### General

On early production units, pilot outages may occur due to a momentary lack of airflow when starting the 739I.

#### 3. Replace L/H Restrictor plate.

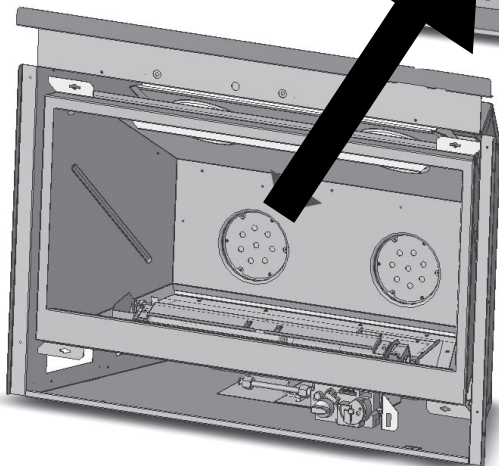
leaving the pilot on will often correct the problem. Changing the left hand restrictor located at the rear of the firebox may be necessary if these solutions are not acceptable. The procedure for changing the L/H restrictor is shown below. series direct vent heater from a cold start. Re-lighting the unit a second time or

The LH restrictor plate is held in place by three fixing screws of the six visible (remove every second screw).

1. Remove pre-installed restrictor plate from firebox LH only, and replace with 'single holed' restrictor plate as supplied.
2. Re-install airduct with four screws, followed by rear log support.

739ILN with serial #'s after 200073 and 739ILP's after 200387 have already been changed in production.
